Accessibility Survey

City of Downey Brookshire Avenue & Civic Center Drive

Date of Inspection 5/25/2017

Disability Access Consultants

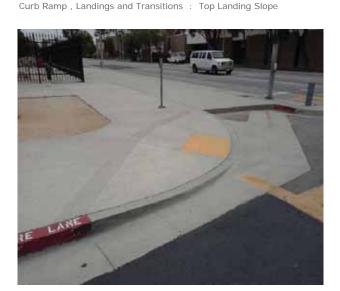
The slope at the top landing is greater than allowed.

On-Site Finding 4.10 percent

Provide a top landing surface that does not exceed the maximum slope and cross slope. Provide a sufficient maneuvering clearance that does not accumulate water.

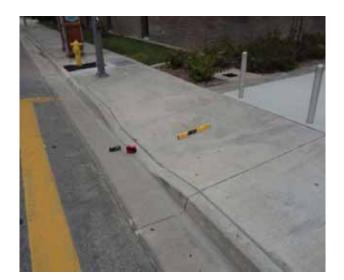
The curb ramp does not provide a detectable warning surface which includes truncated domes.

On-Site Finding Not Found

Provide compliant detectable warnings to surface.

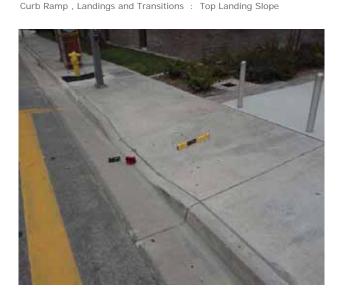
The slope at the top landing is greater than allowed.

On-Site Finding 4.10 percent

Provide a top landing surface that does not exceed the maximum slope and cross slope. Provide a sufficient maneuvering clearance that does not accumulate water.

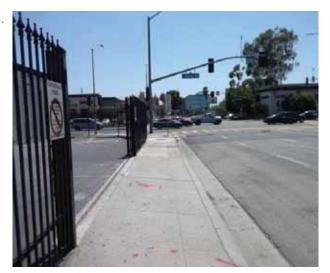
Cross slope at vehicular traffic is not compliant.

On-Site Finding 10.00 percent

Repave the surface to provide a compliant cross slope.

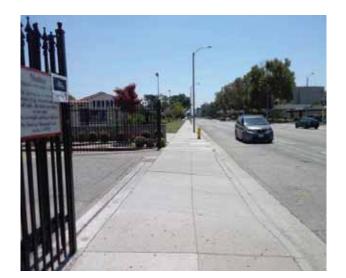
There are no detectable warnings where the pedestrian route crosses vehicular traffic.

On-Site Finding Not Found

Provide detectable warnings.

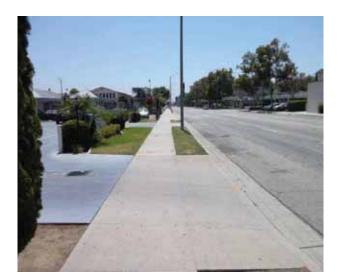
There are no detectable warnings where the pedestrian route crosses vehicular traffic.

On-Site Finding Not Found

Provide detectable warnings.

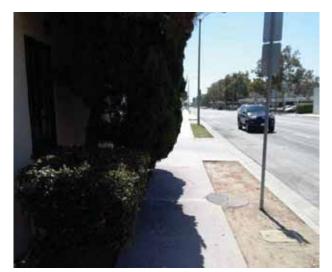
The leading edge of the protruding object is more than 4 inches from the edge of sidewalk.

On-Site Finding 38.00 inches

Install side extensions, modify, relocate, or lower the protruding object so that the leading edge protrudes less than 4 inches from the edge of sidewalk.

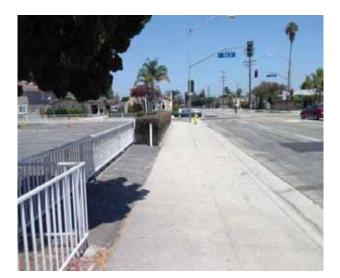
There are no detectable warnings where the pedestrian route crosses vehicular traffic.

On-Site Finding Not Found

Provide detectable warnings.

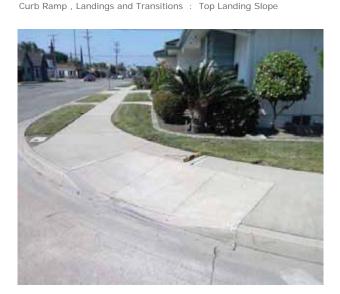
The slope at the top landing is greater than allowed.

On-Site Finding 2.60 percent

Provide a top landing surface that does not exceed the maximum slope and cross slope. Provide a sufficient maneuvering clearance that does not accumulate water.

Change in Level South of 11th Street @ 33.949008260995, -118.122376799583

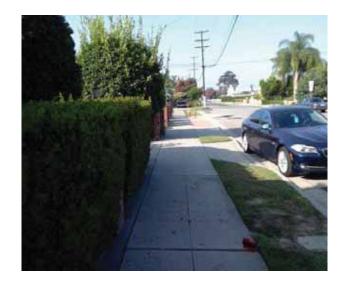
There is a change in elevation greater than recommended value.

On-Site Finding 0.62 inches

Ensure that the change in elevation is within the recommended value.

Change in Level South of Cherokee Drive @ 33.943314331326, -118.125673234463

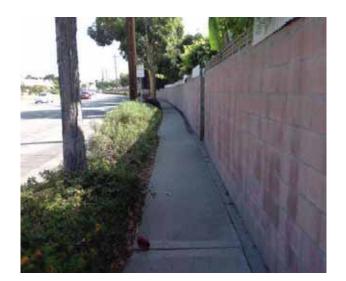
There is a change in elevation greater than recommended value.

On-Site Finding 0.50 inches

Ensure that the change in elevation is within the recommended value.

Change in Level South of Dacosta Street @ 33.950233106983, -118.121397793293

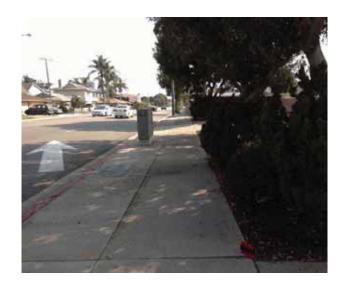
There is a change in elevation greater than recommended value.

On-Site Finding 0.75 inches

Ensure that the change in elevation is within the recommended value.

Change in Level South of Raviller Drive @ 33.954430379184, -118.117727190256

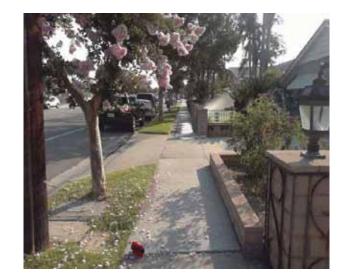
There is a change in elevation greater than recommended value.

On-Site Finding 0.62 inches

Ensure that the change in elevation is within the recommended value.

Change in Level South of Raviller Drive @ 33.954672886863, -118.117473721504

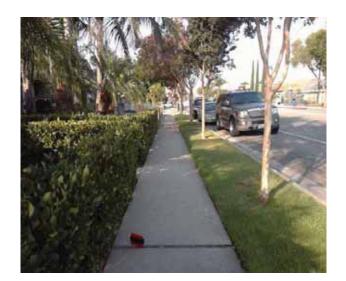
There is a change in elevation greater than recommended value.

On-Site Finding 0.50 inches

Ensure that the change in elevation is within the recommended value.

Change in Level South of Suva Street @ 33.953618307156, -118.118590861559

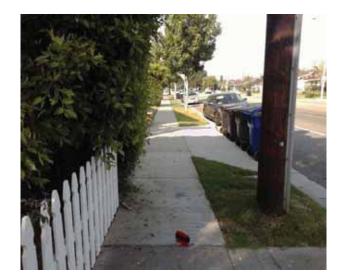
There is a change in elevation greater than recommended value.

On-Site Finding 0.50 inches

Ensure that the change in elevation is within the recommended value.

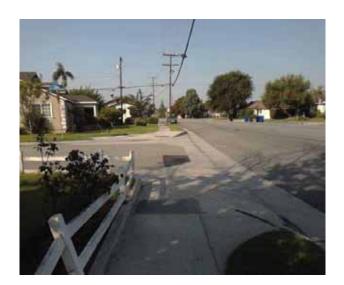
Slope at vehicular traffic is not compliant.

On-Site Finding 8.20 percent

Repave the surface to provide a compliant slope.

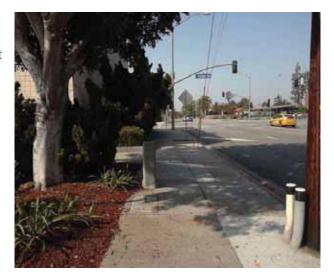
Sidewalk cross slope is not compliant.

On-Site Finding 4.90 percent for 103.00 feet

Repave the sidewalk surface with the recommended cross slope.

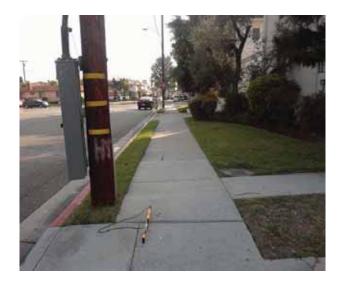
Sidewalk cross slope is not compliant.

On-Site Finding 3.90 percent for 40.00 feet

Repave the sidewalk surface with the recommended cross slope.

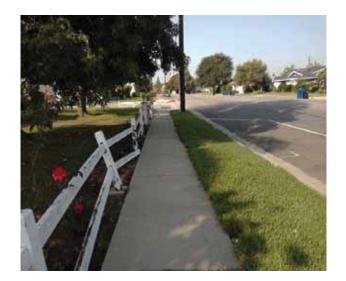
Sidewalk cross slope is not compliant.

On-Site Finding 3.70 percent for 57.00 feet

Repave the sidewalk surface with the recommended cross slope.

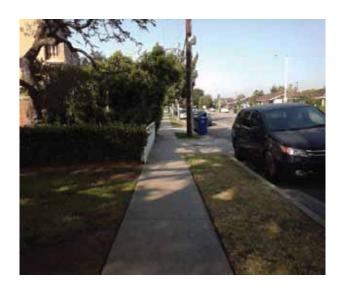
Sidewalk cross slope is not compliant.

On-Site Finding 4.00 percent for 76.00 feet

Repave the sidewalk surface with the recommended cross slope.

Change in Level North of Florence Avenue @ 33.950124084168, -118.121796101332

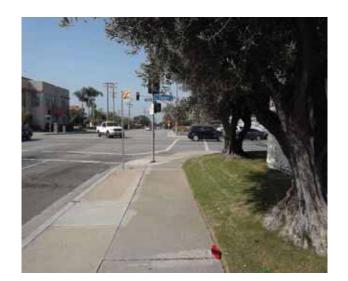
There is a change in elevation greater than recommended value.

On-Site Finding 1.00 inches

Ensure that the change in elevation is within the recommended value.

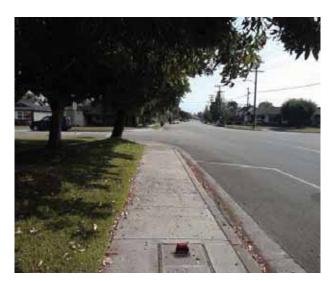
Sidewalk grate opening is not perpendicular to the path.

On-Site Finding Not Perpendicular

Grate opening shall be perpendicular to the path of travel.

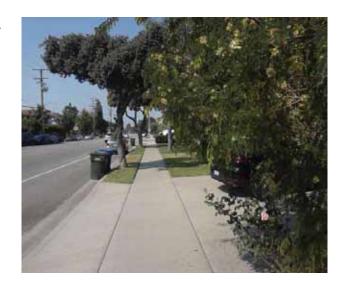
Overhead obstruction height is not compliant.

On-Site Finding 70.00 inches

Provide a compliant vertical clearance height.

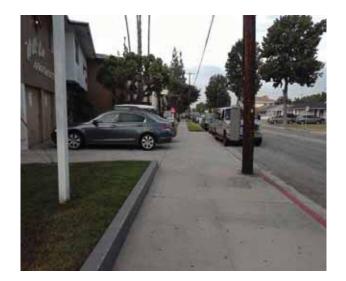
Sidewalk cross slope is not compliant.

On-Site Finding 3.60 percent for 18.00 feet

Repave the sidewalk surface with the recommended cross slope.

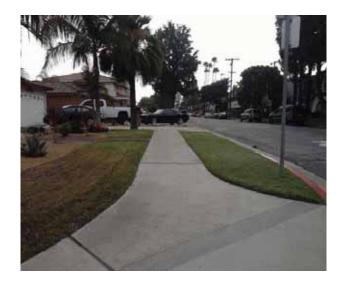
Sidewalk cross slope is not compliant.

On-Site Finding 3.00 percent for 38.00 feet

Repave the sidewalk surface with the recommended cross slope.

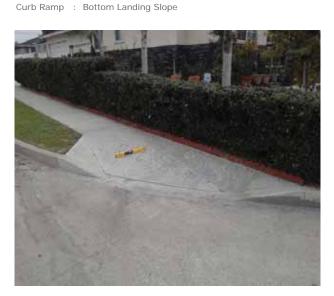
The bottom landing of the curb ramp is on the street, and the slope of the bottom landing is not compliant.

On-Site Finding 33.00 percent

Ensure the bottom landing slope is compliant and provides a smooth transition.

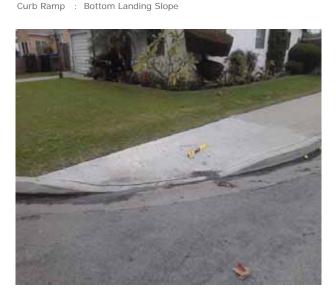
The bottom landing of the curb ramp is on the street, and the slope of the bottom landing is not compliant.

On-Site Finding 6.40 percent

Ensure the bottom landing slope is compliant and provides a smooth transition.

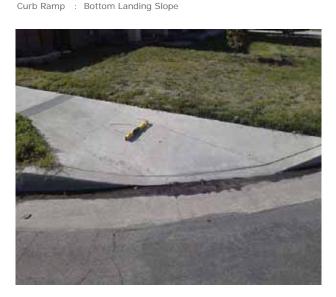
The bottom landing of the curb ramp is on the street, and the slope of the bottom landing is not compliant.

On-Site Finding 6.00 percent

Ensure the bottom landing slope is compliant and provides a smooth transition.

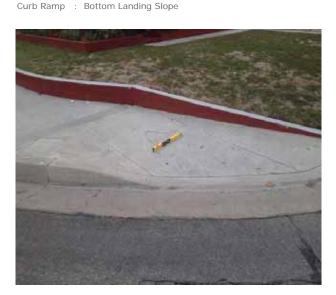
The bottom landing of the curb ramp is on the street, and the slope of the bottom landing is not compliant.

On-Site Finding 8.50 percent

Ensure the bottom landing slope is compliant and provides a smooth transition.

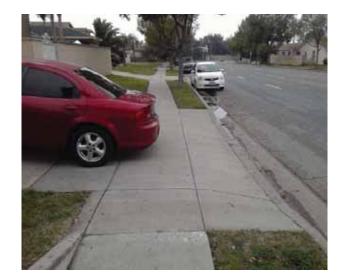
There are no detectable warnings where the pedestrian route crosses vehicular traffic.

On-Site Finding Not Found

Provide detectable warnings.

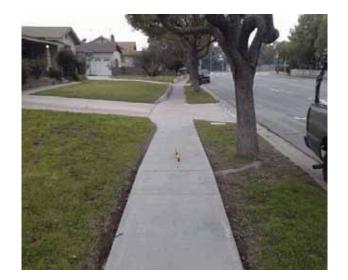
Sidewalk running slope is not compliant.

On-Site Finding 7.20 percent for 8.00 feet

Repave the sidewalk surface with the recommended running slope.

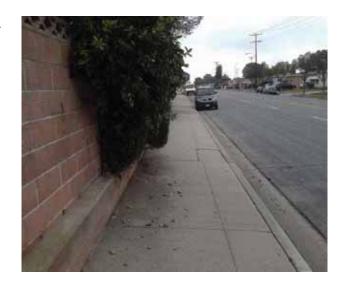
Overhead obstruction height is not compliant.

On-Site Finding 48.00 inches

Provide a compliant vertical clearance height.

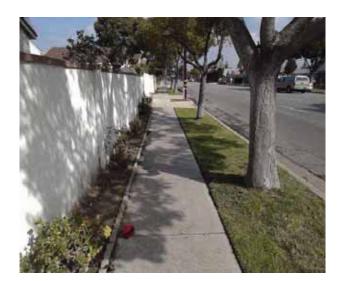
There is a change in elevation greater than recommended value.

On-Site Finding 0.50 inches

Ensure that the change in elevation is within the recommended value.

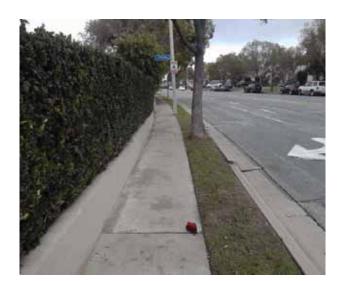
There is a change in elevation greater than recommended value.

On-Site Finding 0.37 inches

Ensure that the change in elevation is within the recommended value.

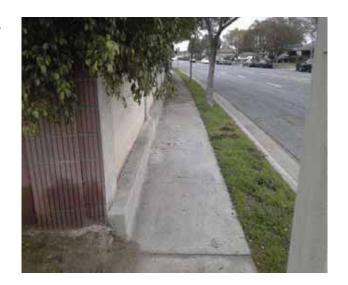
Overhead obstruction height is not compliant.

On-Site Finding 56.00 inches

Provide a compliant vertical clearance height.

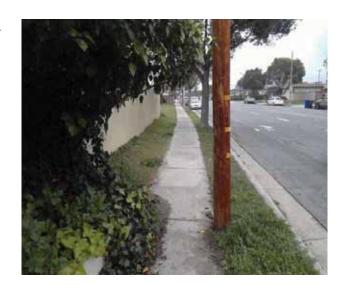
Overhead obstruction height is not compliant.

On-Site Finding 67.00 inches

Provide a compliant vertical clearance height.

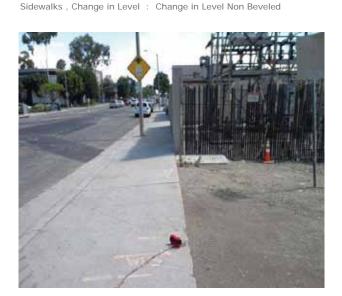
There is a change in elevation greater than recommended value.

On-Site Finding 0.62 inches

Ensure that the change in elevation is within the recommended value.

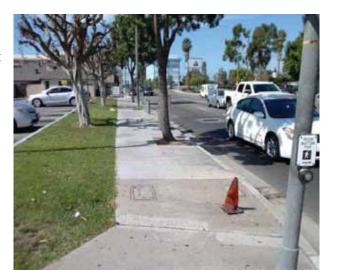
Sidewalk cross slope is not compliant.

On-Site Finding 5.30 percent for 117.00 feet

Repave the sidewalk surface with the recommended cross slope.

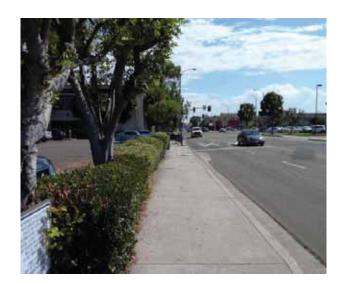
Sidewalk cross slope is not compliant.

On-Site Finding 3.80 percent for 59.00 feet

Repave the sidewalk surface with the recommended cross slope.

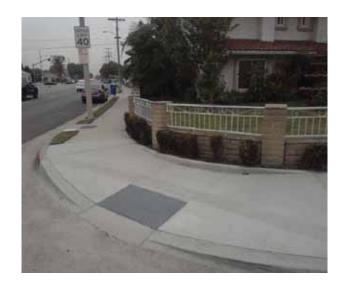
The running slope is greater than allowed.

On-Site Finding 8.90 percent

Provide a compliant curb ramp.

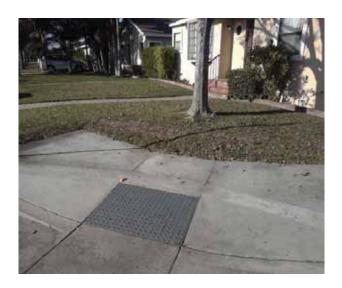
The cross slope is greater than allowed.

On-Site Finding 4.10 percent

Provide a compliant curb ramp.

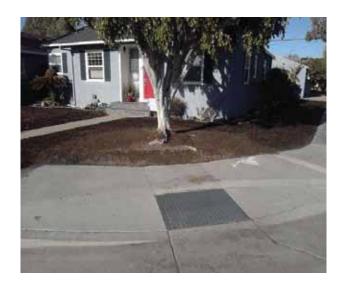
The cross slope is greater than allowed.

On-Site Finding 3.30 percent

Provide a compliant curb ramp.

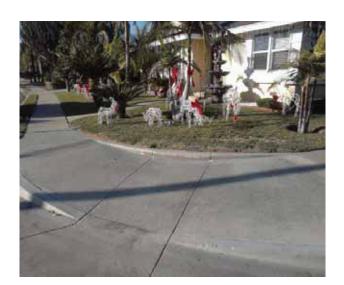
The curb ramp does not provide a detectable warning surface which includes truncated domes.

On-Site Finding Not Found

Provide compliant detectable warnings to surface.

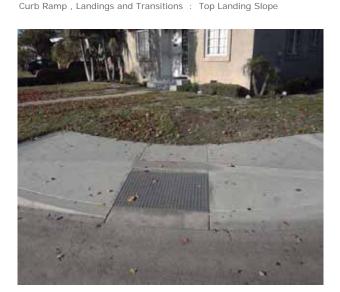
The slope at the top landing is greater than allowed.

On-Site Finding 2.50 percent

Provide a top landing surface that does not exceed the maximum slope and cross slope. Provide a sufficient maneuvering clearance that does not accumulate water.

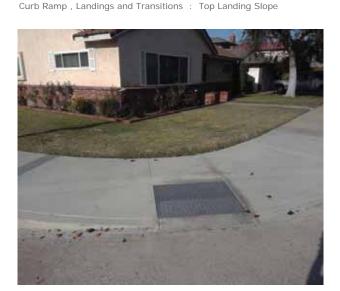
The slope at the top landing is greater than allowed.

On-Site Finding 3.00 percent

Provide a top landing surface that does not exceed the maximum slope and cross slope. Provide a sufficient maneuvering clearance that does not accumulate water.

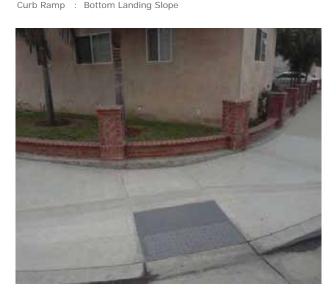
The bottom landing of the curb ramp is on the street, and the slope of the bottom landing is not compliant.

On-Site Finding 5.50 percent

Ensure the bottom landing slope is compliant and provides a smooth transition.

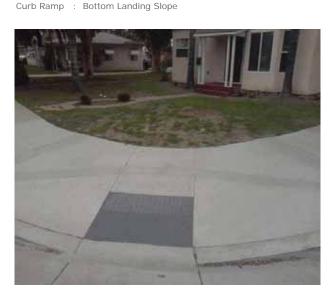
The bottom landing of the curb ramp is on the street, and the slope of the bottom landing is not compliant.

On-Site Finding 5.70 percent

Ensure the bottom landing slope is compliant and provides a smooth transition.

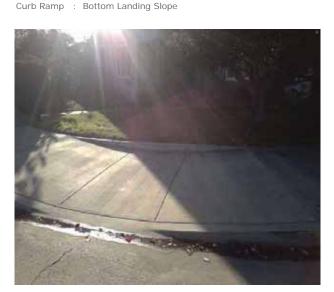
The bottom landing of the curb ramp is on the street, and the slope of the bottom landing is not compliant.

On-Site Finding 5.30 percent

Ensure the bottom landing slope is compliant and provides a smooth transition.
